**PROPOSAL FOR DRAFT AMENDMENT TO REGULATION No. 17
VEHICLE SEATS, THEIR ANCHORAGES AND ANY HEAD RESTRAINTS**

A. PROPOSAL

Figure 1

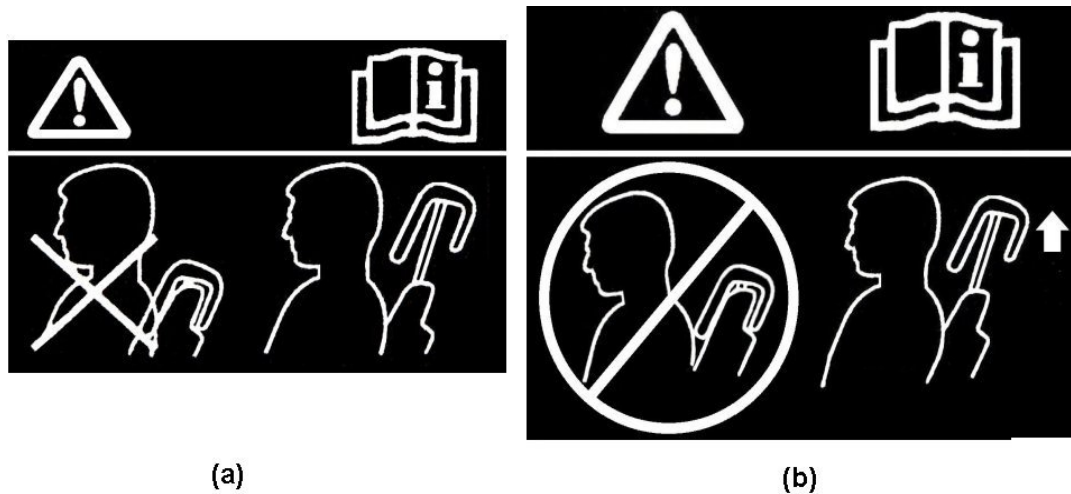
- 5.6.3.5. The head restraint shall be marked with a label in the form of a pictogram which may include explanatory text. The label shall either provide an indication when the head restraint is in a non-use position or provide information to enable an occupant to determine whether the head restraint is in a non-use position. The label shall be

durably affixed and located such that it is clearly visible by an occupant when entering the vehicle to the designated seating position. Examples of possible designs of pictograms are shown in Figure 1.

Figure 1-1

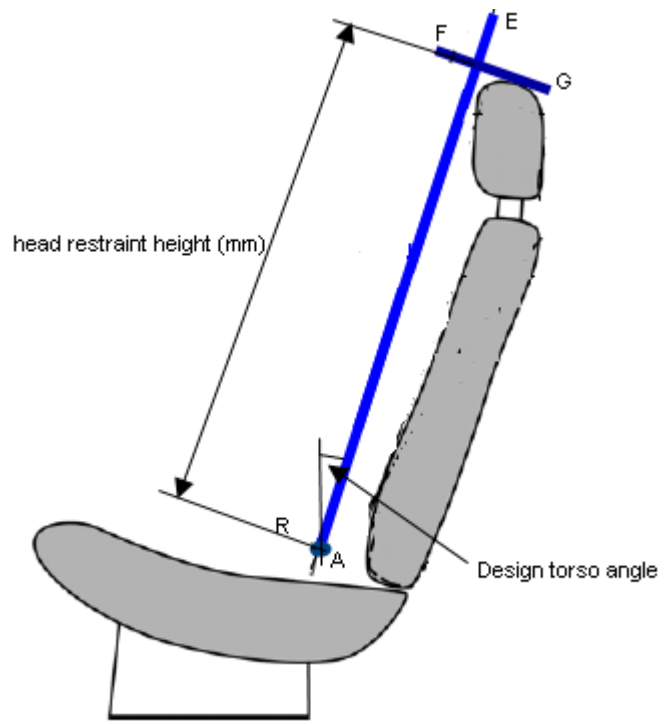
1. Height measuring apparatus. The height measurement apparatus consists of (see Figure 1-1 below):
 - 1.1. A straight edge AE. The lower point A is placed at the R-point location. The line AE shall be parallel to the design torso angle.

- 1.2. A straight edge FG, perpendicular to the line AE and in contact with the top of the head restraint.
2. Procedure for height measurement. Demonstrate compliance with paragraph 5.5.2. of the regulation in accordance with paragraphs 3. and 4. of this annex, using the height measurement apparatus defined in paragraph 1 of this Annex. The seat shall be adjusted such that its H-point coincides with the R-point, in accordance with the requirements of Annex 13, paragraph 2.2.2. If the seat back is adjustable, it is set at the design seat back angle. The height of the head restraint shall be the distance between point A and the intersection of lines AE and FG.

Figure 2-1

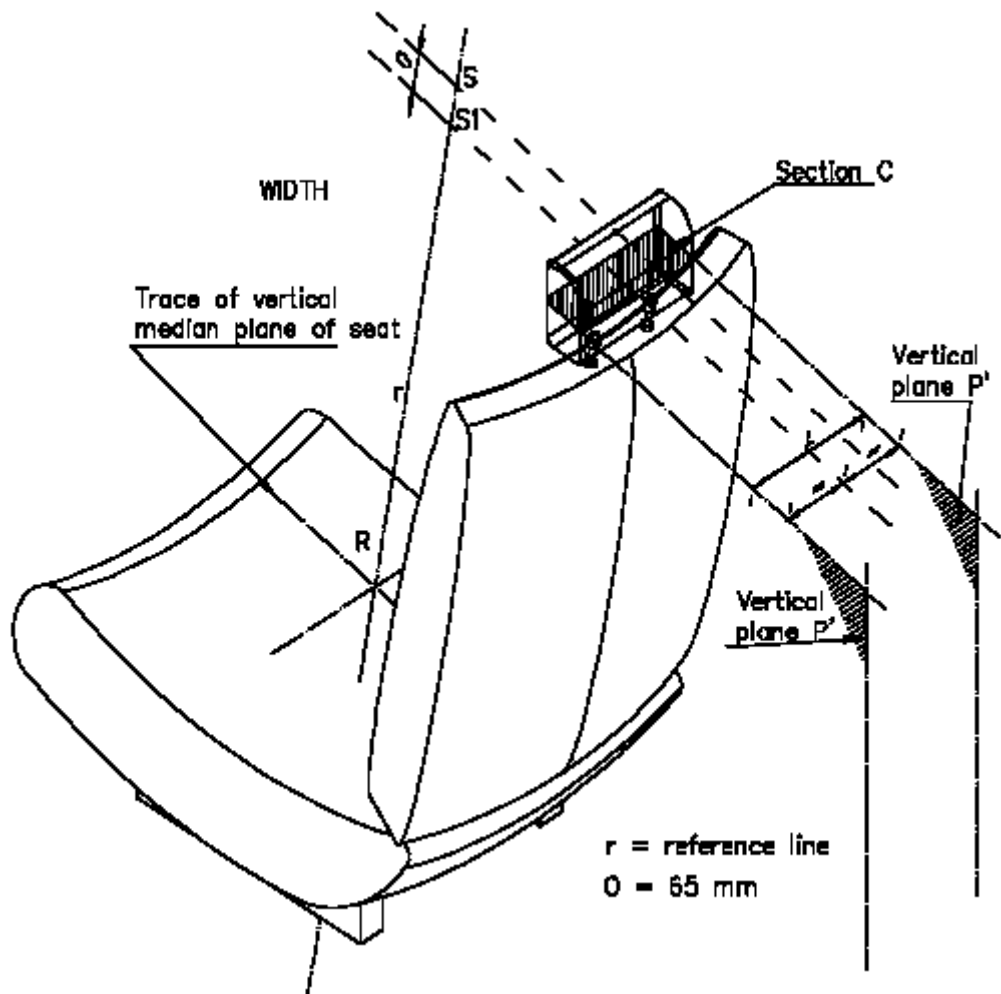
1. Purpose:
To demonstrate compliance with paragraph 5.5.4. of this regulation.
2. Procedure for width measurement Using calipers, measure the maximum dimension perpendicular to the vehicle vertical longitudinal plane of the intersection of the head restraint with a plane that is perpendicular to the manikin torso reference line 'r', defined in Annex 7, and 68 ± 3 mm below the top of the head restraint, as shown in Figure 2-1.

Figure 3-1

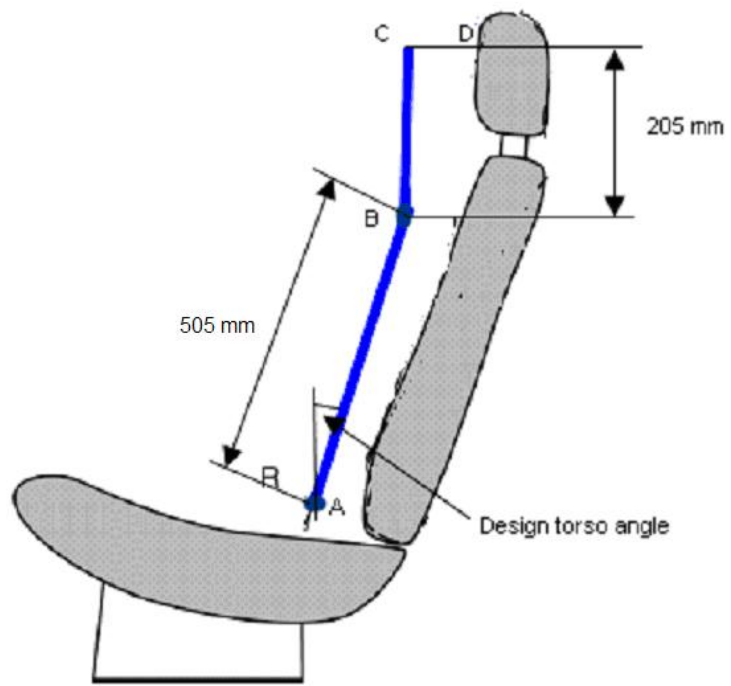
The backset measurement apparatus consists of (see Figure 3-1):
- 1.1. A straight edge (lower arm) AB. The lower point A is placed at the R-point location. Point B is located at a distance of 505mm from the R-point. The line AB shall be parallel to the design torso angle.

- 2.5. Establish point D on the head restraint, point D being the intersection of a line drawn, from point C horizontally in the X direction, with the front surface of the head restraint.

- 2.6. Measure the distance CD. The backset shall be the measured distance CD minus 73mm.

Figure 4-1 - Measurement of a vertical gap "a".

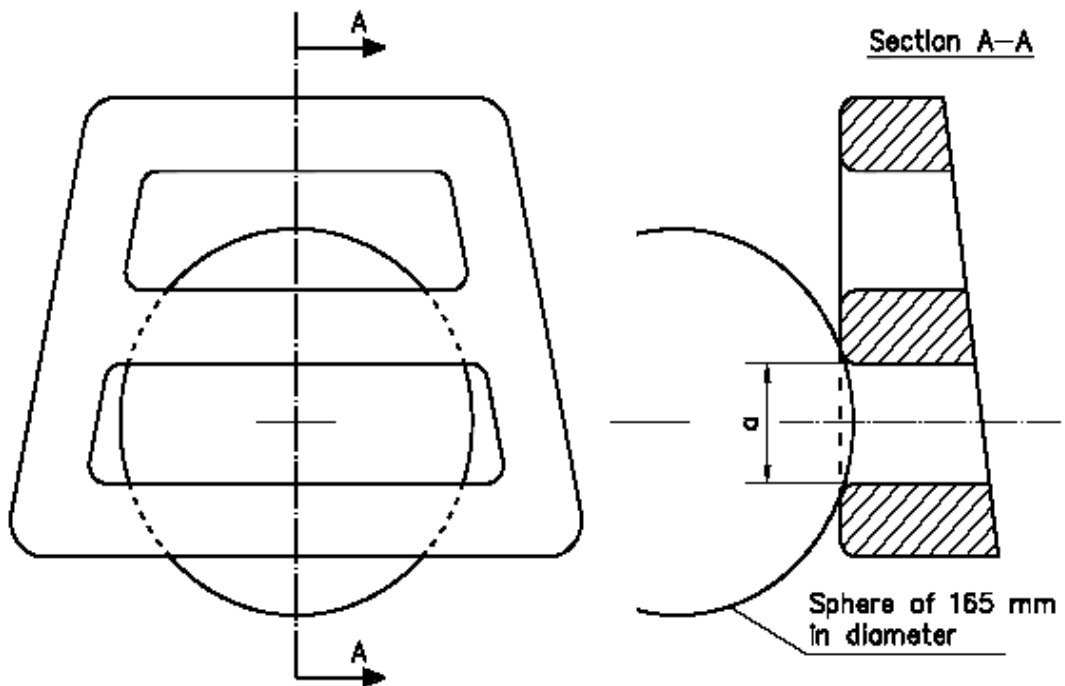
2.2. Determine the gap dimension by measuring the straight line distance between the inner edges of the two furthest contact points, as shown in Figures 4-1 and 4-2.

Figure 7-1.

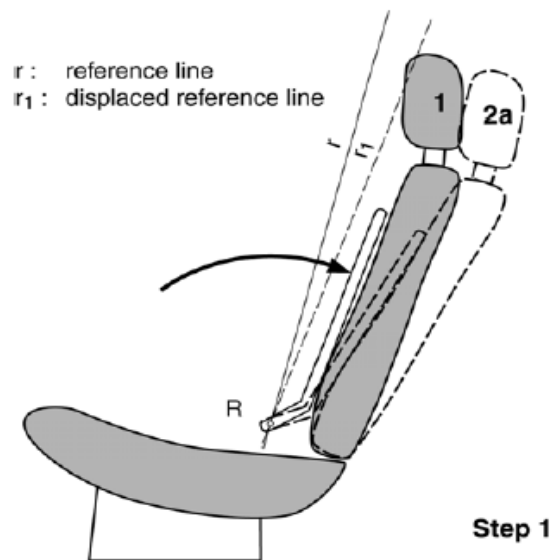
1.1.3. Establish the displaced torso reference line 'r₁' by creating a rearward moment of 373 ± 7.5 Nm about the R-point by applying a force to the seat back through the back pan at the rate of 2.5 Nm/second to 37.3 Nm/second. The initial location on the back pan of the moment generating force vector has a height of $290 \text{ mm} \pm 13 \text{ mm}$. Apply the force vector normal to the torso reference line and maintain it within 2 degrees of a vertical plane parallel to the vehicle longitudinal centreline. Constrain the back pan to rotate about the R-point. Rotate the force vector direction with the back pan. (see Figure 7-1)

- 1.2.4. Establish the displaced torso reference line 'r' by creating a rearward moment of 373 ± 7.5 Nm about the R-point by applying a force to the seat back through the back pan at the rate of 2.5 Nm/second to 37.3 Nm/second. The initial location on the back pan of the moment generating force vector has a height of 290 mm \pm 13 mm. Apply the force vector normal to the torso reference line and maintain it within 2 degrees of a vertical plane parallel to the vehicle longitudinal centreline. Constrain the back pan to rotate about the R-point. Rotate the force vector direction with the back pan. (see Figure 7-1)

Figure 7-2.

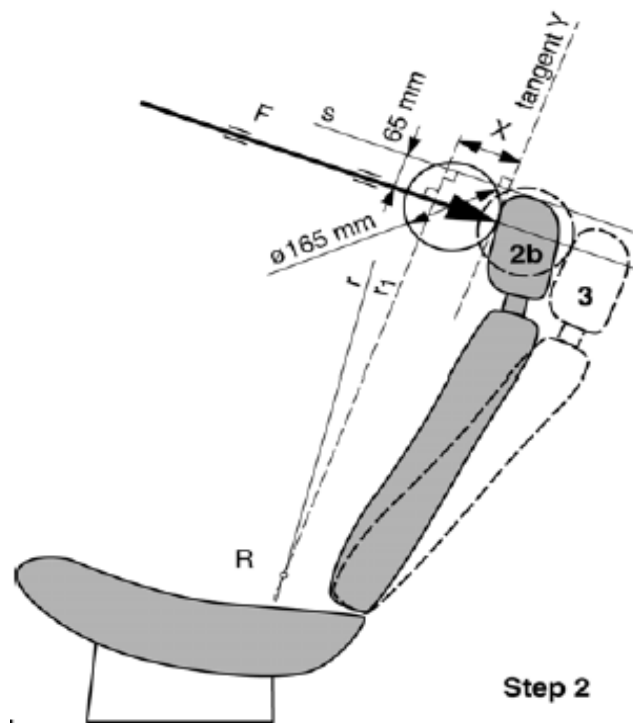
- 4.4. Maintain the position of the back pan as established in paragraph 4.3 of this Annex. Using a 165 ± 2 mm diameter spherical headform with a surface roughness of less than $1.6 \text{ }\mu\text{m}$ root mean square, establish the headform initial reference position by applying, perpendicular to the displaced torso reference line, a rearward initial load passing through the centre of gravity of the smallest of the sections of the gap, along transversal planes parallel to the reference line that will produce a 36.5 ± 0.5 Nm moment about the R-point (see Figure 7-2).

- Displaced position by applying to the manikin's back a moment of 373 Nm about the R-point, defining the position of the displaced torso reference line 'r₁'.
- 1.1.4. Maintain the position of the back pan as established in paragraph 1.1.3. of this Annex. Using a 165 ± 2 mm diameter spherical head form with a surface roughness of less than 1.6 μm, root mean square, establish the headform initial reference position by applying, perpendicular to the displaced torso reference line, a rearward initial load at the seat centreline at a height 65 ± 3 mm below the top of the head restraint that will produce a 36.5 ± 0.5 Nm moment about the R-point. (see Figure 7-2)

Figure 8-1 Sled pulse acceleration corridor.

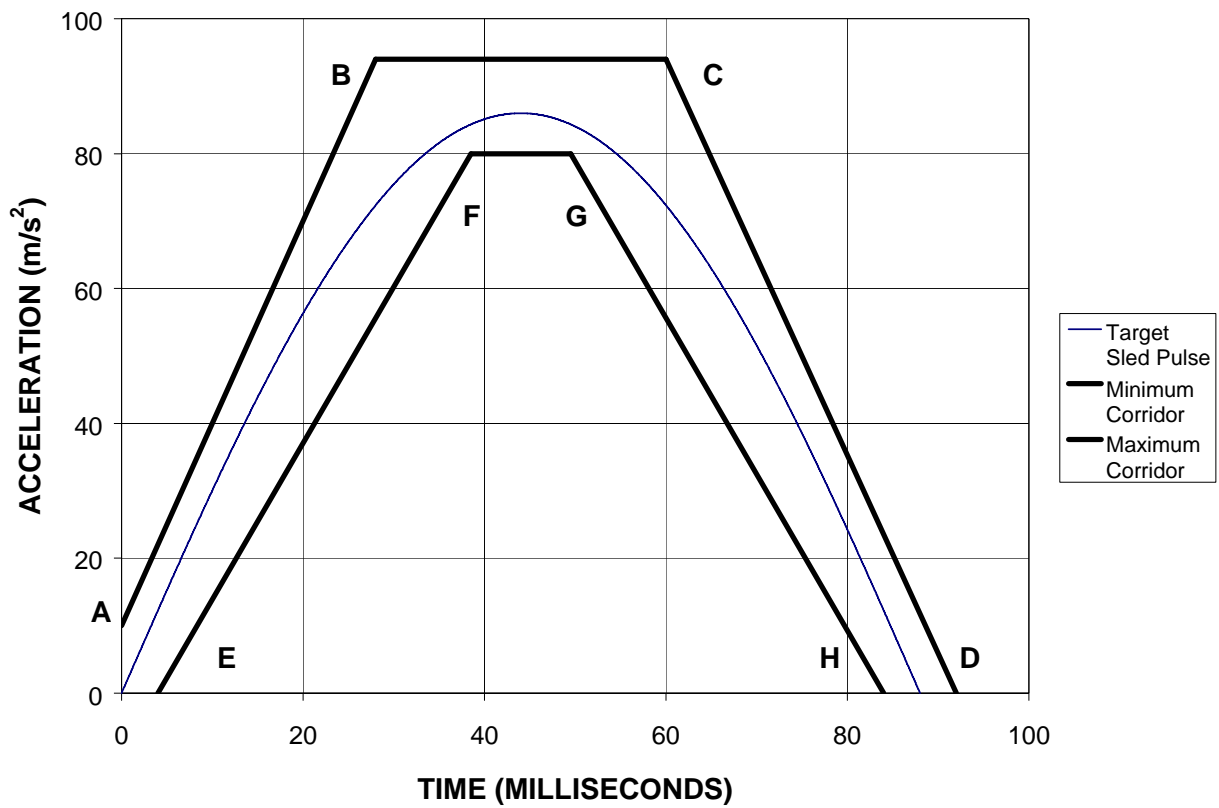
All of the points on the acceleration vs. time curve fall within the corridor described in Figure 8-1 and Table 8-1 when filtered to channel class 60, as specified in the [SAE Recommended Practice J211/1 (rev. Mar 95)]. Measure the maximum rearward angular displacement.

The target acceleration with time expressed in milliseconds is $a = 86 \sin(\pi t/88) \text{ m/s}^2$, for $V = 17.3 \pm 0.6 \text{ km/h}$. The time zero for the test is defined by the point when the sled acceleration achieves 2.5 m/s^2 (0.25 G's).

Figure 9-1.

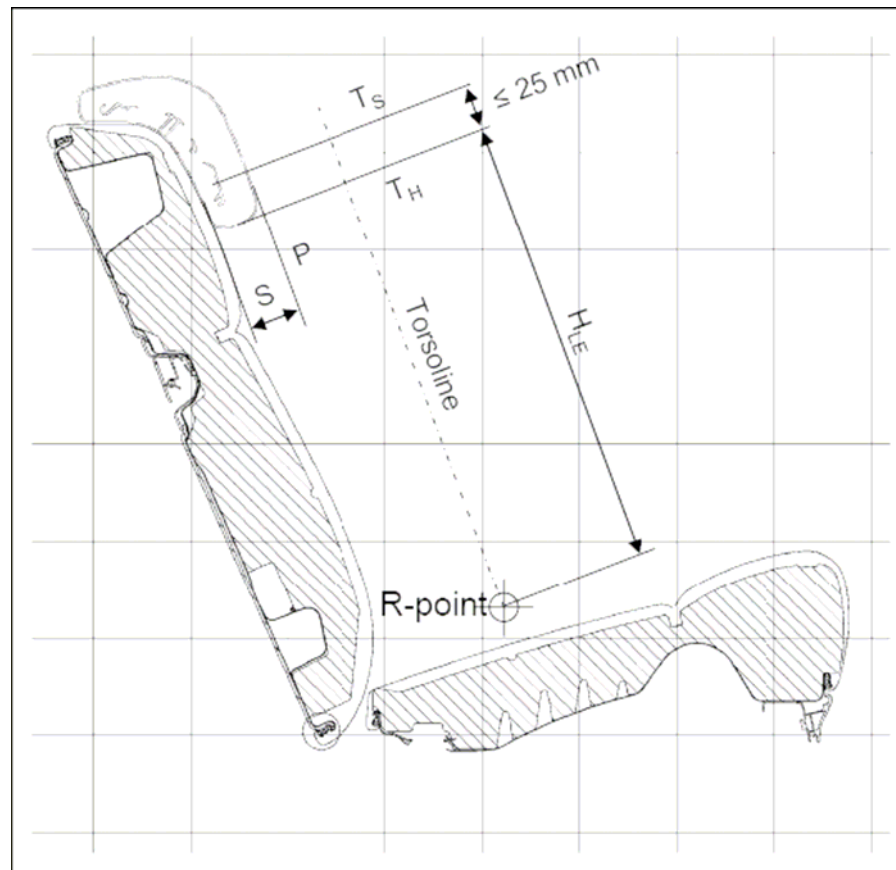
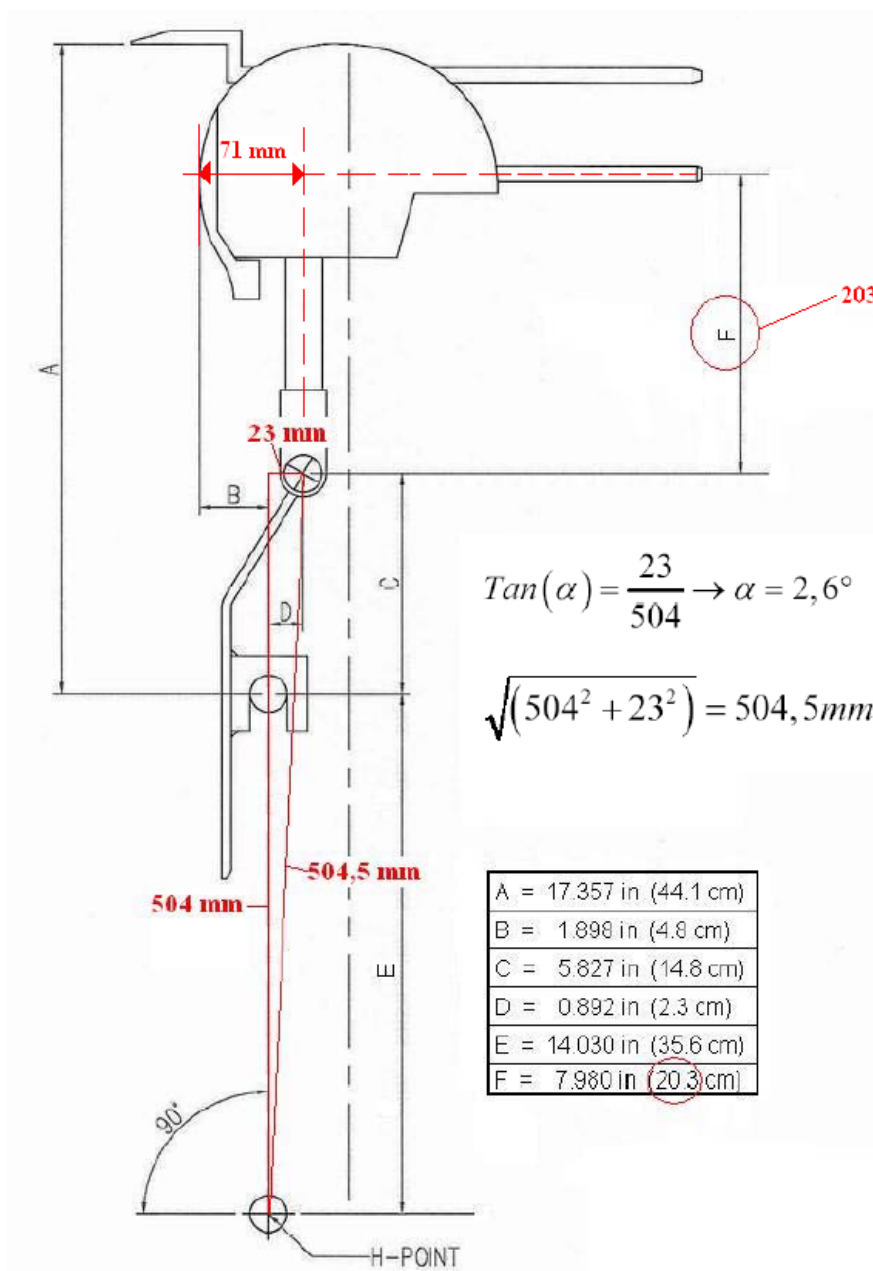
- 5.6.3.3. When measured in accordance with Annex 9, the lower edge of the head restraint (H_{LE}) shall be not more than 400 mm, but not less than 250 mm from the R-Point and the thickness (S) shall not be less than 25 mm.

- 4.1. The H_{LE} and S dimensions are defined in Figure 9-1. which shows a vertical fore-aft plane passing through the R-point (i.e. at the mid point of the designated seating position) intersecting the seat cushion, seat back and the head restraint.
 - 4.2. Adjust the head restraint to the non-use position.
 - 4.2.1. H_{LE} is the distance from the R-point to the lower edge of the head restraint measured along the torso line.

- 4.2.2. S is the maximum thickness of the lower edge of the head restraint (within 25mm of the head restraint lower edge) measured perpendicular to the torso line between T_H and T_S from line P.
- 4.2.3. P is a line parallel to the torso line which intersects the head restraint at T_S
- 4.2.4. T_H is the line perpendicular to the torso line and tangent to the lower edge of the head restraint.
- 4.2.5. T_S is the line parallel to and 25 mm from T_H .
